THE SHOPS AT BROADWAY RETAIL PROJECT

Responses to Comments and Final Environmental Impact Report
State Clearinghouse #2012072062

Prepared for
City of Oakland

December 2013

The Shops at Broadway Retail Project
Figure 3-2
 Site Plan and Surrounding Context

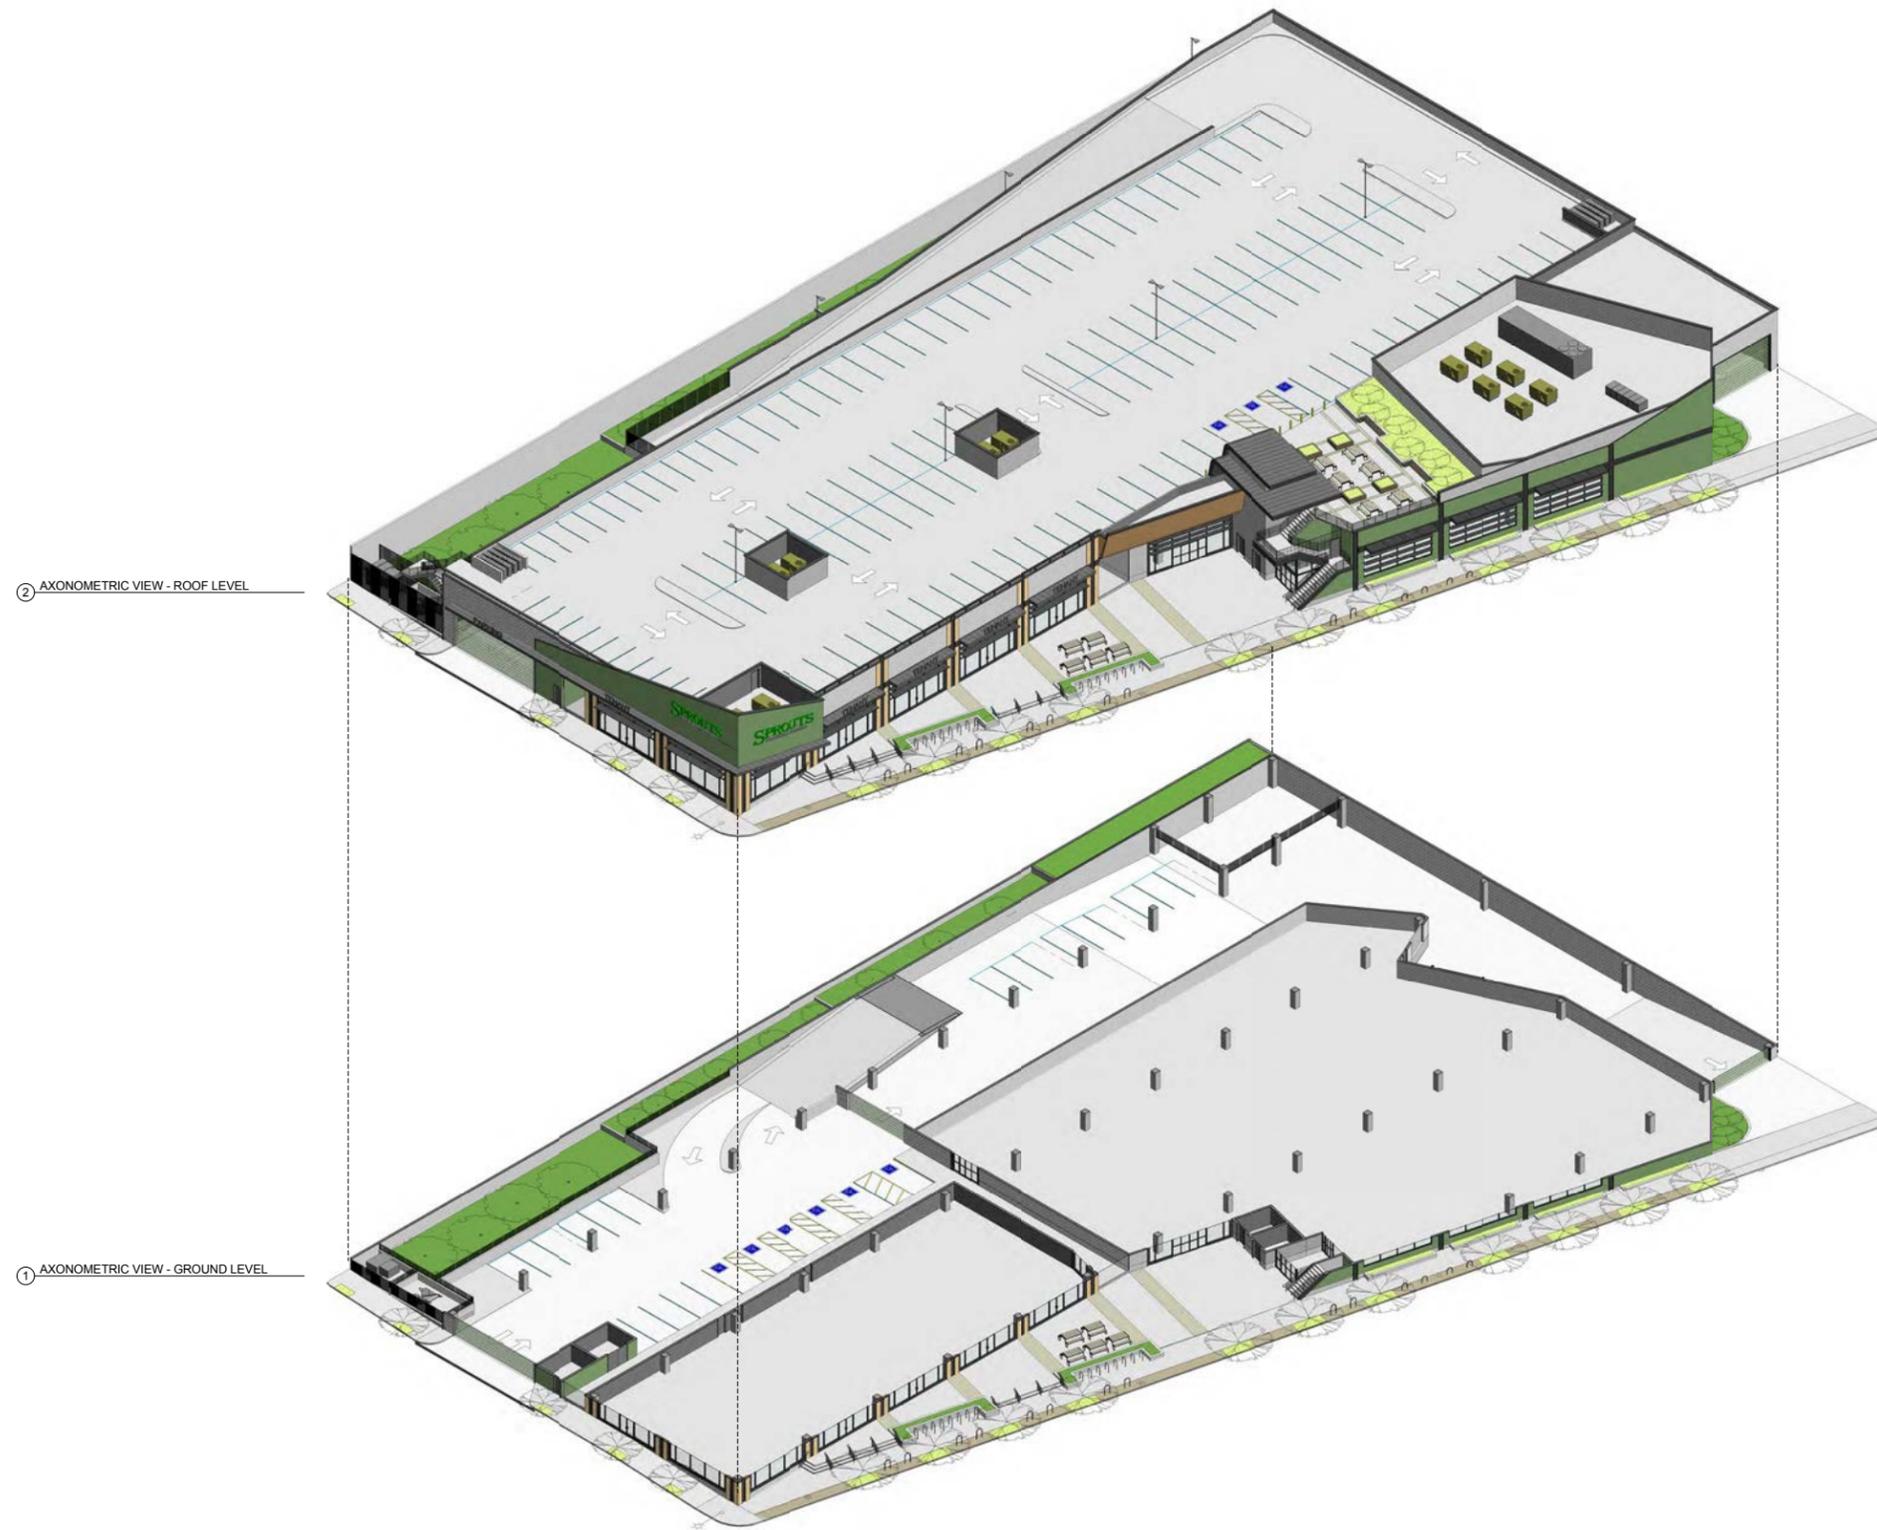
3. The following figures on page 3-3 and pages 3-9 through 3-12 of the Draft EIR are revised to reflect Project updates to the location and number of mechanical equipment areas; parking space counts and distribution; building square footage area references; as well as exterior aesthetics updates (e.g., signage and exterior material updates).
